VILLAGE OF DOWNERS GROVE
 Report of the Village

SUBJECT:	SUBMITTED BY:
2001 63rd Street - Planned Unit Development Amendment, Special Use and Plat of Subdivision	Stan Popovich, AICP Director of Community Development

**VILLAGE OF DOWNERS GROVE
REPORT FOR THE PLAN COMMISSION
FEBRUARY 5, 2018 AGENDA**

SUBJECT:	TYPE:	SUBMITTED BY:
17-PLC-0041 2001 63 rd Street	PUD Amendment, Special Use and Plat of Subdivision	Rebecca Leitschuh, AICP Senior Planner

EAST ELEVATION

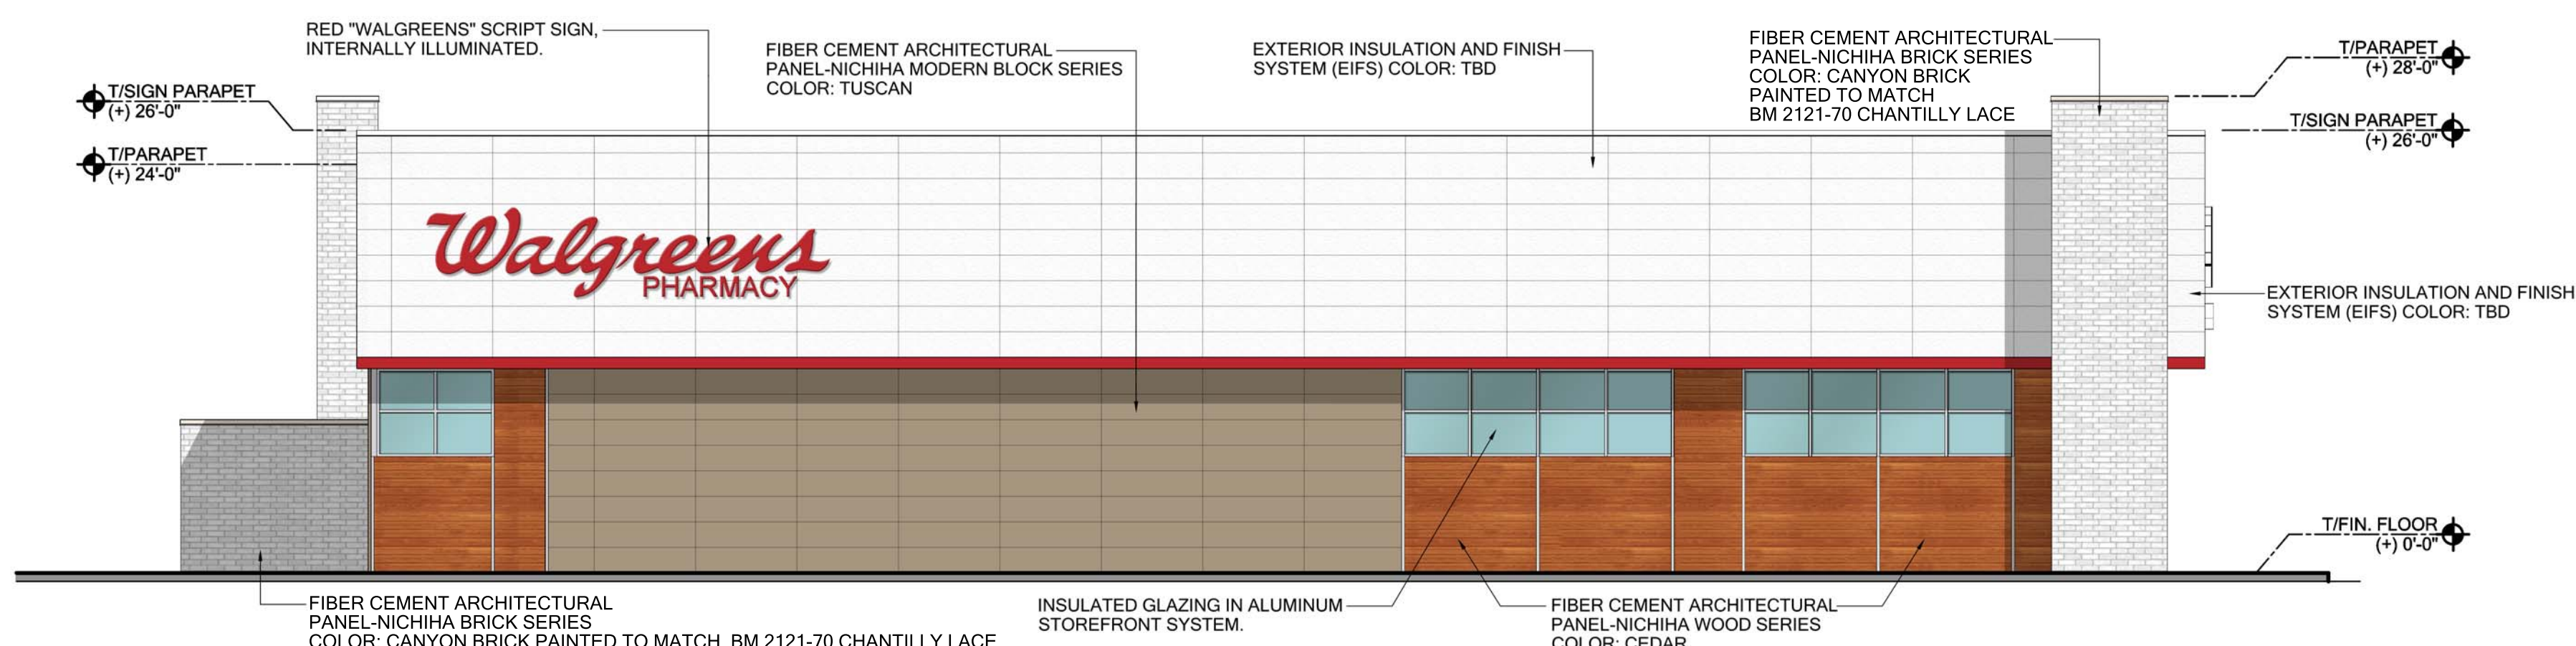
The Woodward Avenue (east) elevation continues to wrap the corner with wood panels, windows, and the white EIFS overhang. Staff requests a condition be made to extend the EIFS design element across the entire length of the eastern wall so as to bring greater design detail to the east elevation. A vertical pier, identical to the one on the western elevation, intersects the horizontal planes. The dumpster enclosure, while in a street yard, is designed to complement the building, incorporating the same fiber cement panel system.

This item was discussed at the February 20, 2018 Village Council meeting. Based on Council direction, the petitioner has revised the east elevation so the left side of the elevation mimics the right side of the elevation. The new windows on the left side of the elevation will be opaque spandrel glass. The spandrel glass will appear as a window; however, you will not be able to see through the spandrel glass. The revised elevations are attached.
